The Columbia Historic Zoning Commission will meet on Wednesday, February 21, 2024 at 4:00 PM in Council Chambers on the basement level of City Hall, 700 N. Garden Street, to consider the following:

Historic Zoning Staff Report

ADA REMODEL GLOVER SECOND HAND
1200 S HIGH STREET, COLUMBIA TN 38401

1
A-2
ENLARGED RAMP PLAN
SCALE 3/4" = 1'-0"

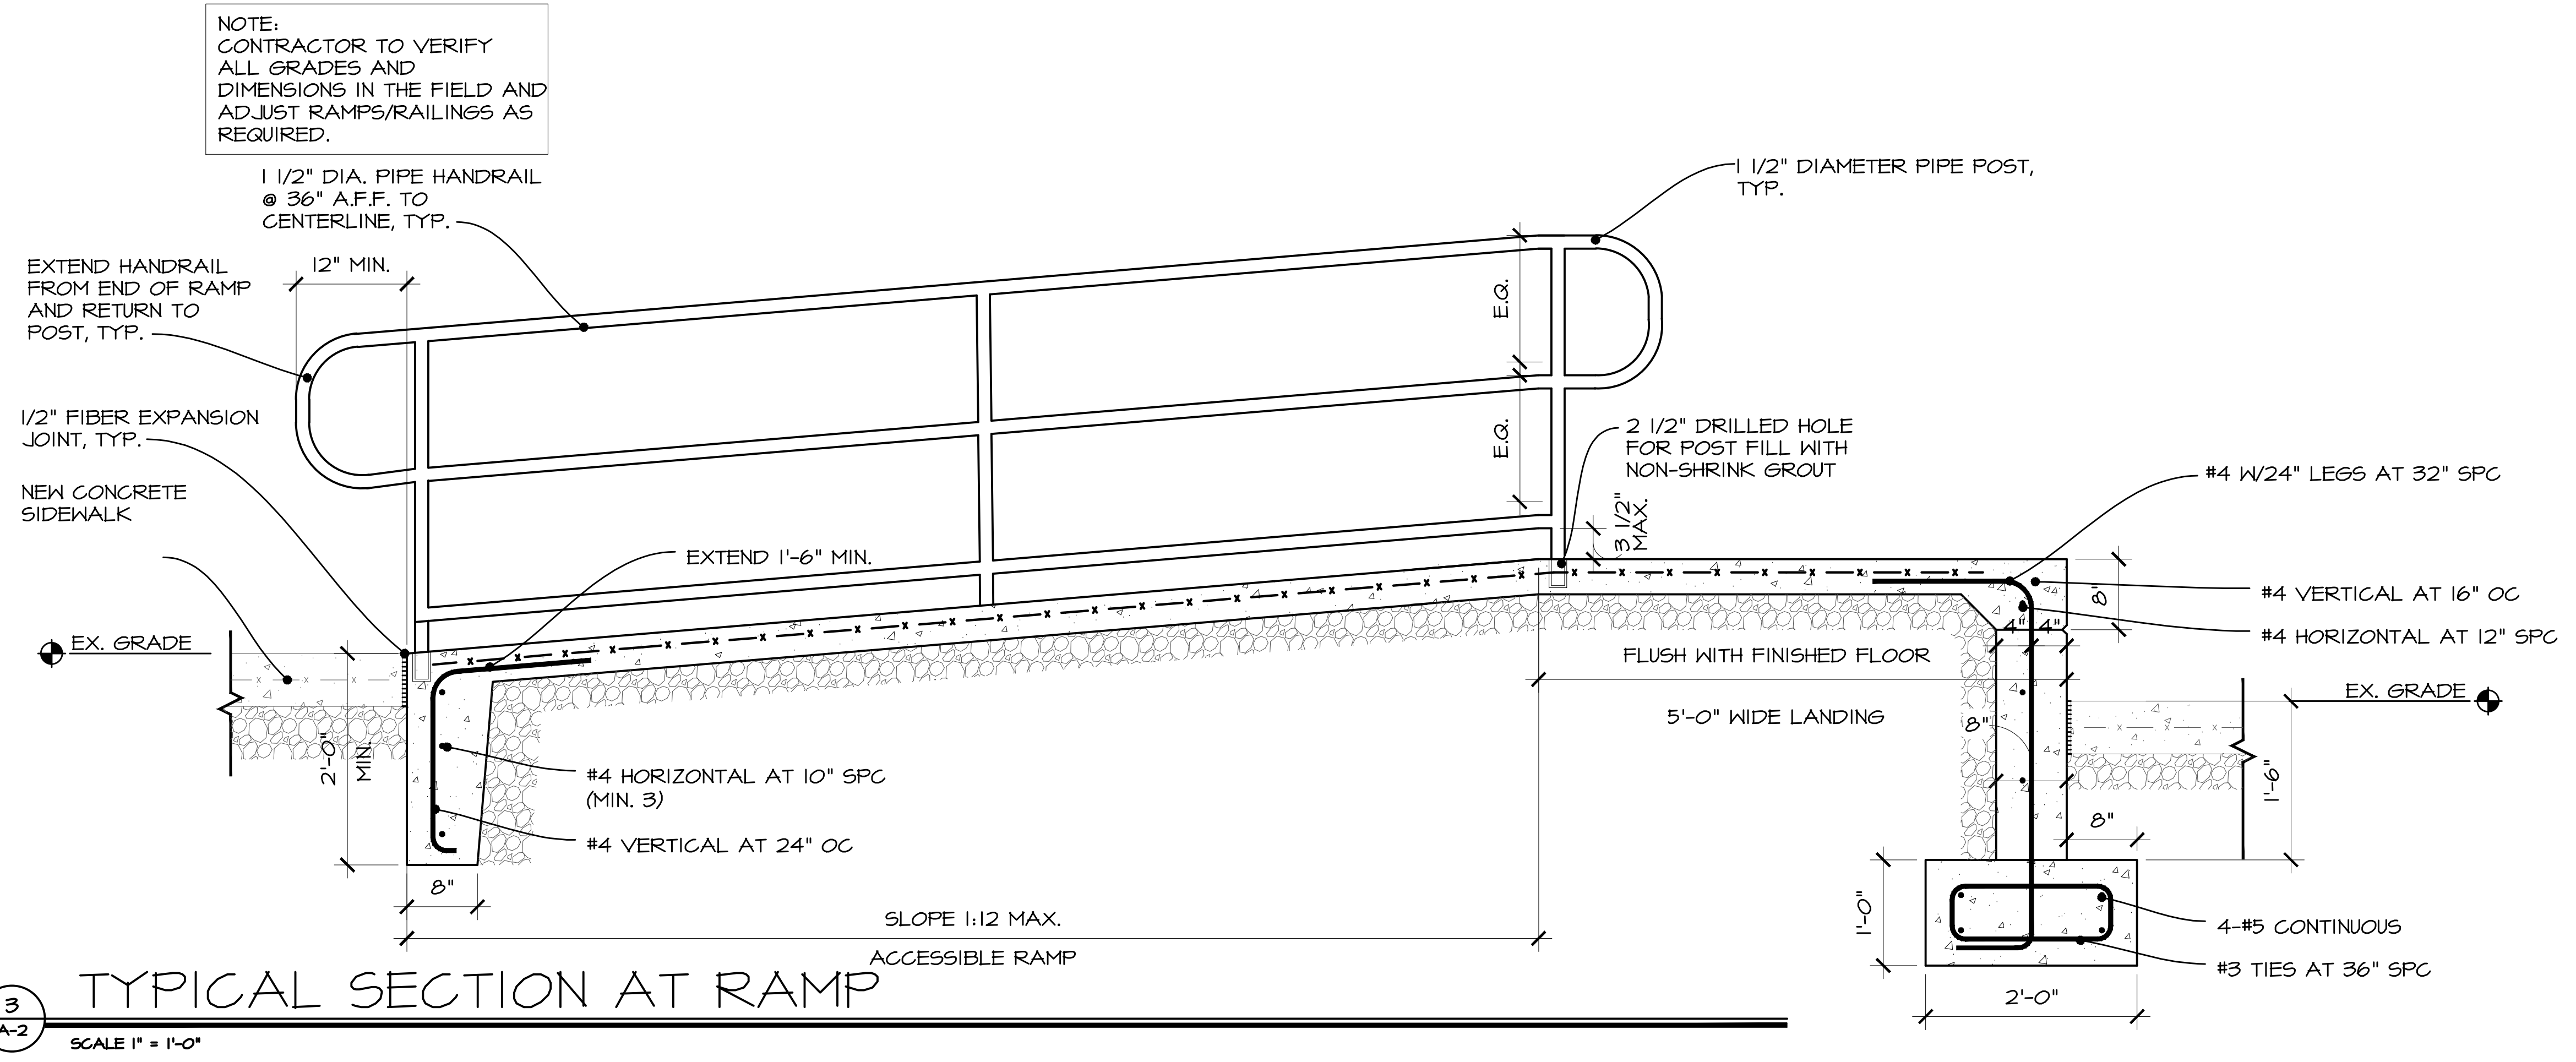
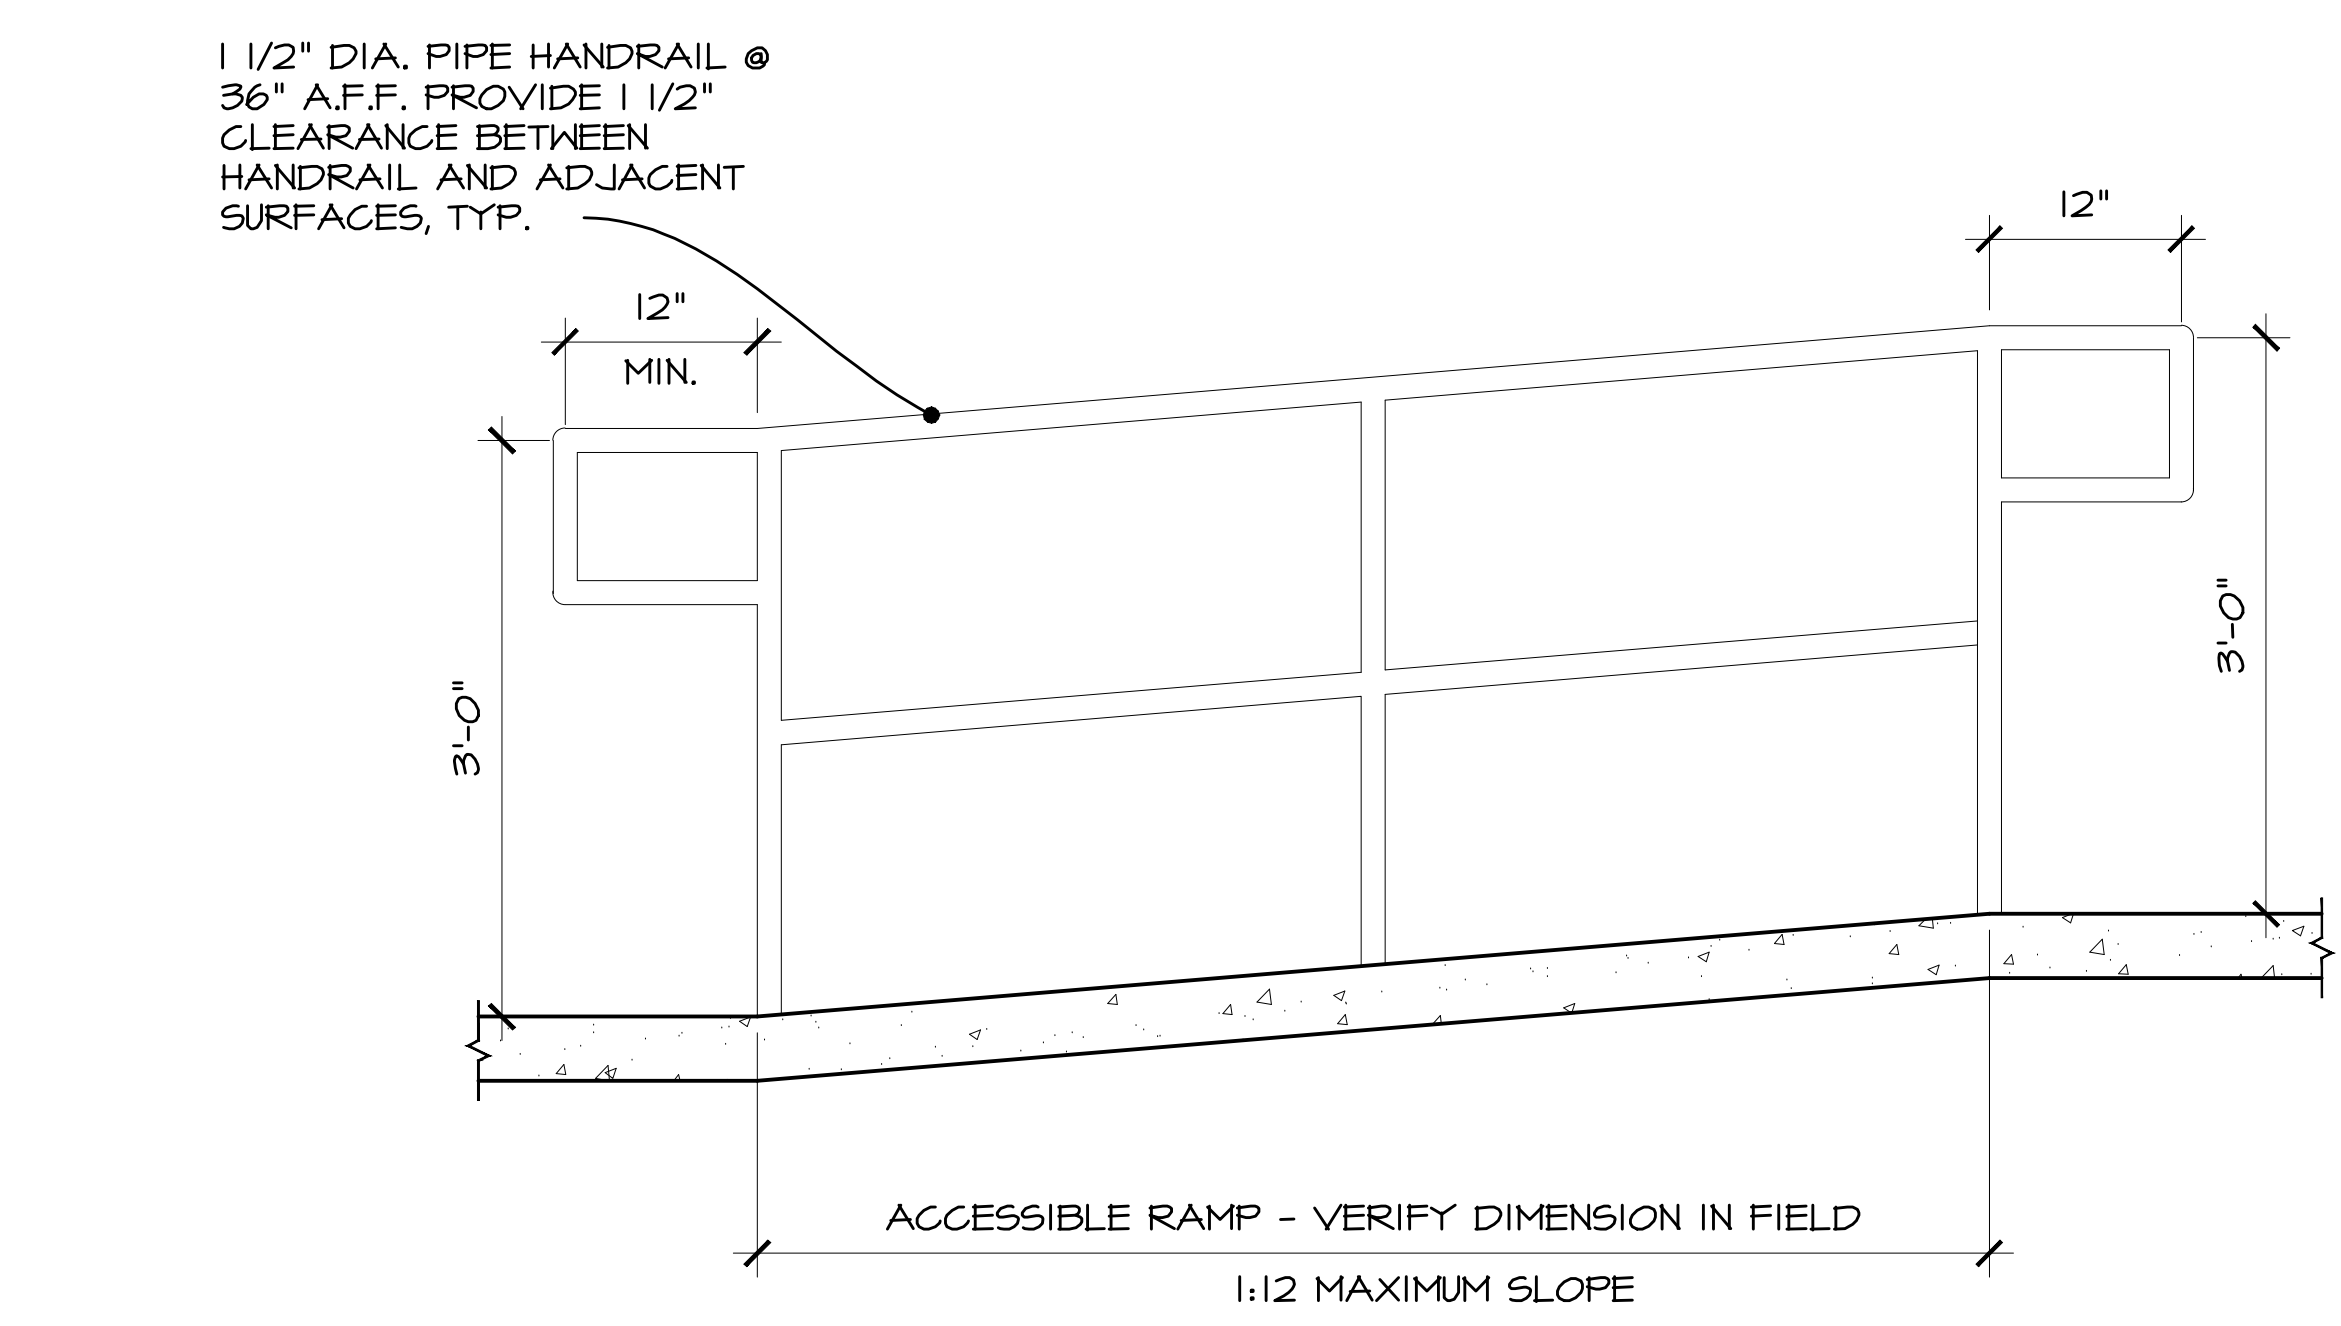
The proposed design submitted by the applicant is a typical handicap ramp design. The lot is situated on a corner with two frontages; South High Street and West 11th Street, with the primary entrance being located at the front of the structure parallel with South High Street. The proposed placement is the most appropriate location providing direct access to the establishment for persons with limited mobility. The lot configuration is prohibitive of construction anywhere else on site. Attention should be given to the proposed features of the ramp considering the visual impact.

Staff recommends modification to the design of the ramp to soften this impact. The suggested conditions are as follows:

- **Piping material proposed for the handrail is prohibited per 7.22 (d). Staff suggests a more compatible material, subject to Commission determination, be a part of Conditional approval.**
- **The proposed ramp description indicates standard concrete face for ramp section that will run parallel with frontage on South High. Staff suggests the Commission consider adding a condition to the approval that the applicant clad the exterior face of the ramp with a more suitable material; such as brick face or stone face veneer, or other material Commission deems appropriate in order to soften the feature in the frontage.**

- Handrails is must be made of *[identify allowable material]*.
- The proposed ramp description indicates concrete face of the ramp section parallel with the frontage on South High must be clad with brick face or stone face veneer.

See page 2
for placement.
Will be above 7.5'
from pavement

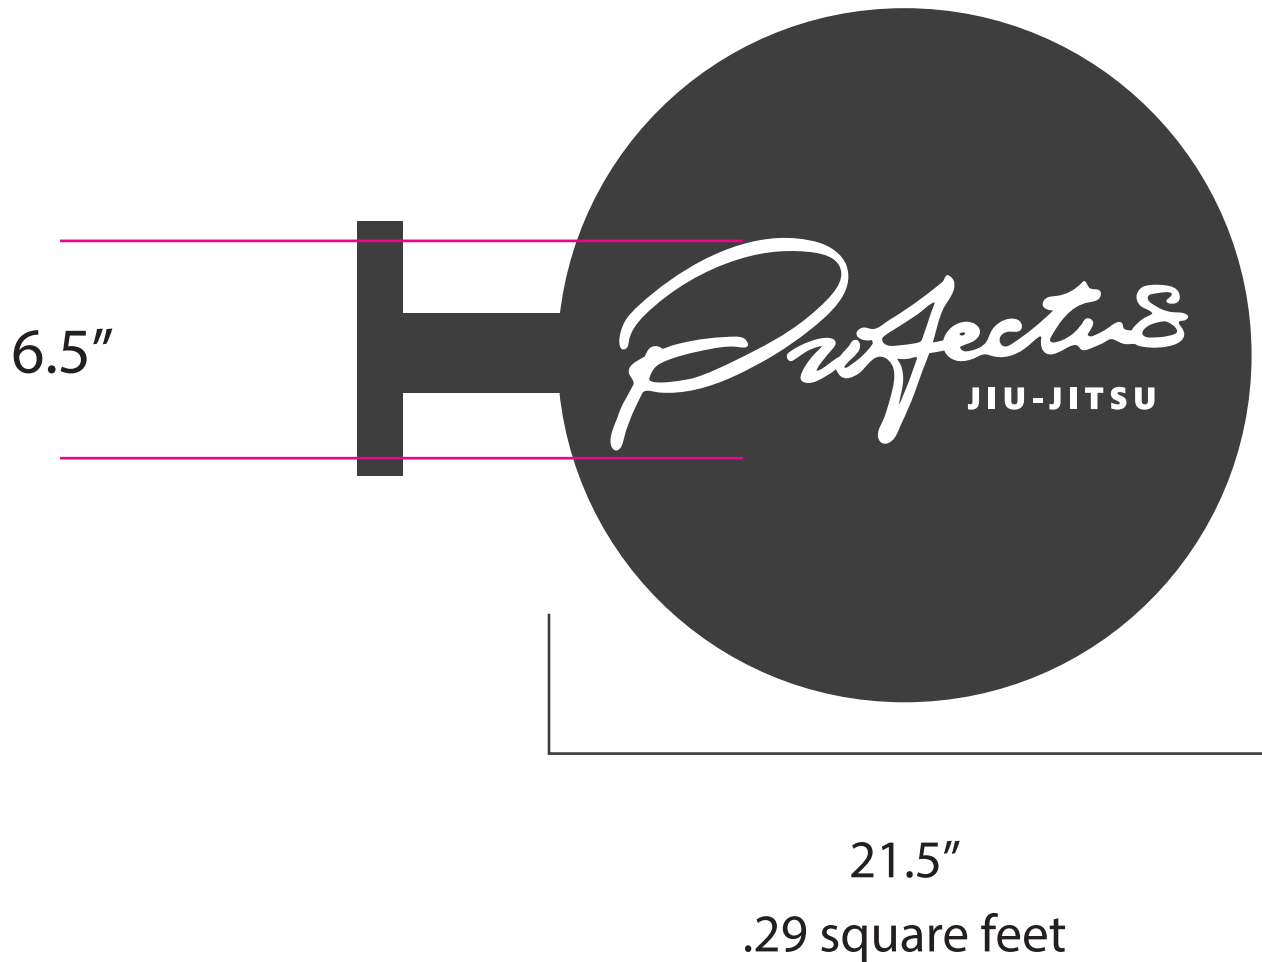
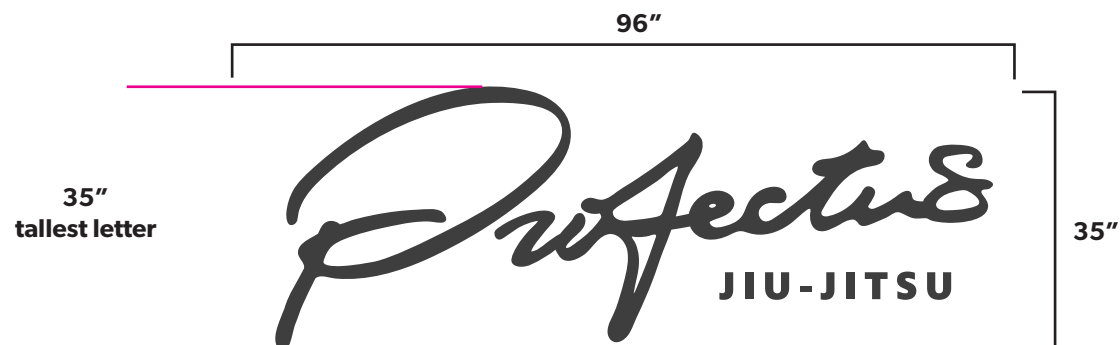
The applicant is requesting approval for the addition of two new signs on the frontage façade of 817 South Main Street, a non-contributing ca. 1960s two-story brick building located in the Downtown Historic District. Both signage proposals, as submitted, meet all of the Design Guidelines with the exclusion of **Section 8.6 (d)**, which states that *“Sign lettering shall be legible but not out of scale with the specific sign, building, or district. Lettering should generally not exceed 18 inches in height on any sign unless the characteristics of a building warrant a larger typeface.”*

The content of the proposed wall sign identifies the business with which it is associated and measures a total of 23.3 sq./ft. As submitted, it will be positioned approximately mid-span of the front façade, which measures a total of 33 feet across. Proposed sign width is shown at 8', substantially smaller than the allowed 2 sq./ft. per linear foot with a maximum of 40 sq./ft. on any one façade per the Historic Guidelines. However, the proposed height of the tallest lettering of signage is 35 inches and does exceed the maximum allowed 18 inches per **Section 8.6 (d)** of the Historic Design Guidelines.

Staff submits that the building façade elevation at which the wall signage is proposed warrants a larger typeface due to the placement of signage in relation to the vertical elevation of the wall area used. There are no architectural features on this wall space. The addition of signage here would enhance the aesthetics of the façade frontage.

Sawcuts minimum 1 1/4" deep
Maximum spacing not to exceed 8'

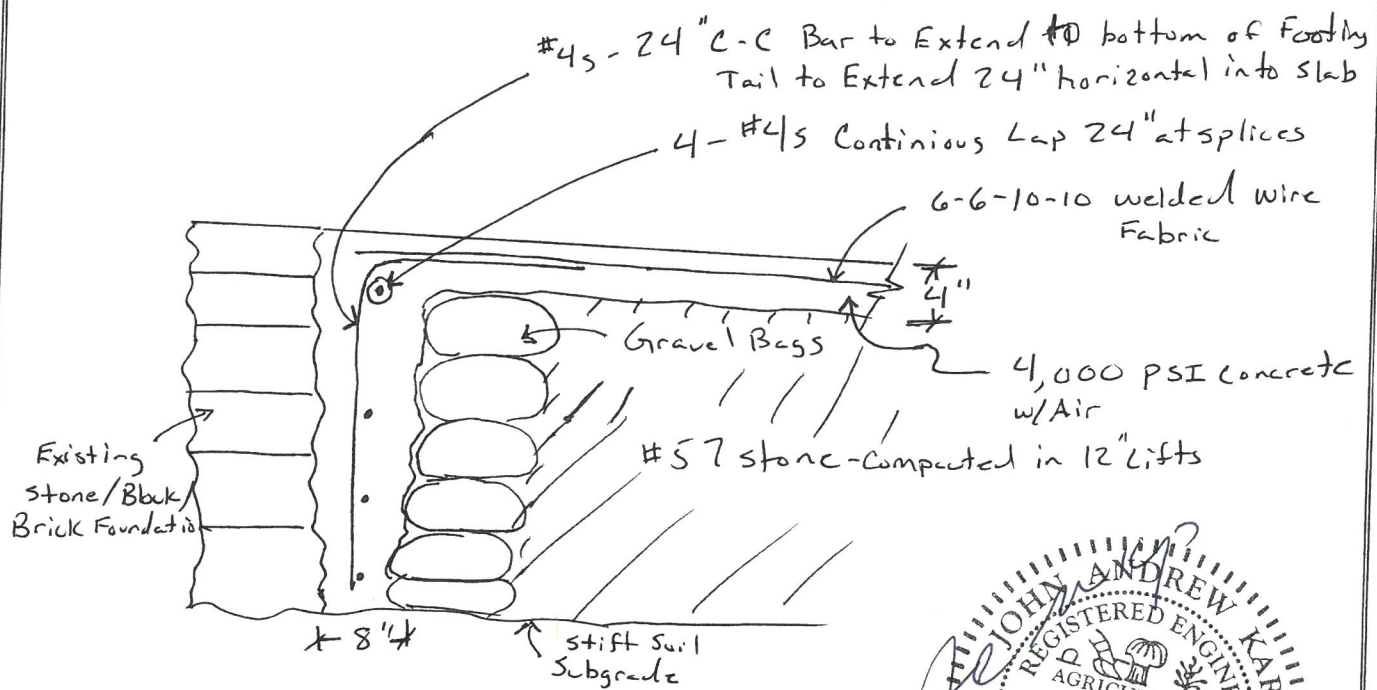
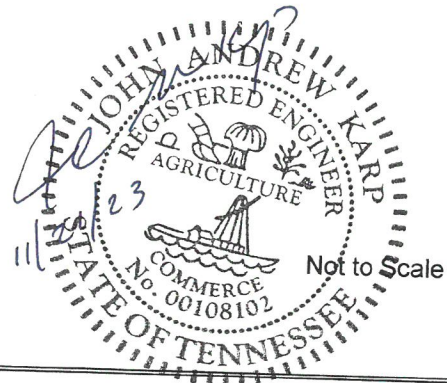
The applicant is requesting approval to remove a deteriorated wood-planked front porch floor and replace it with a more structurally sufficient poured concrete floor. As seen in the attached pictorial submittals, the existing flooring is a mixture of wood plank and plywood. This flooring has succumbed to deterioration and poses a safety concern to the applicant.

Staff concurs with the applicant regarding the structural deterioration of the existing flooring. Furthermore, staff submits that the replacement of the existing wood-plank/plywood mix flooring is necessitated and the applicant has chosen a material typically used for porch floor construction and is relevant to the historical significance of the structure specific to Bungalow architecture.
